Y1155A-01

# Modification Recommended Service Note

# Y1155A Distribution Board with Generic Screw Terminals for Driving 16 Switch Coils

Serial Numbers: Y1155-26511 Rev 002 and below

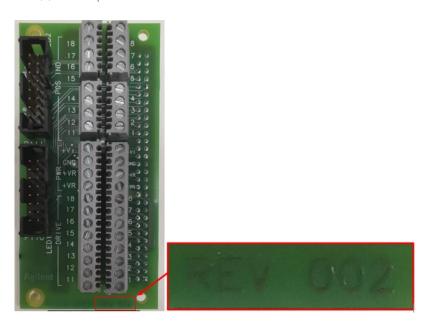
Instrument within the serial number range may experience shorts on PCA between terminals 7 to 17, and terminals 8 to 18. This is due to the presence of solder between the via hole and the connector lead, therefore causing the connections between the faulty terminals.

2. Perform continuity test using a multimeter at the bottom of PCA between terminals 7 to 17, and terminals 8 to 18, as shown in the figures below.

- 3. If the continuity test fails, the instrument does not require modification.
- 4. For users encountering connection between the abovementioned terminals, please contact the nearest Keysight Technologies' Customer Contact at <a href="https://www.keysight.com/find/contactus">www.keysight.com/find/contactus</a>.
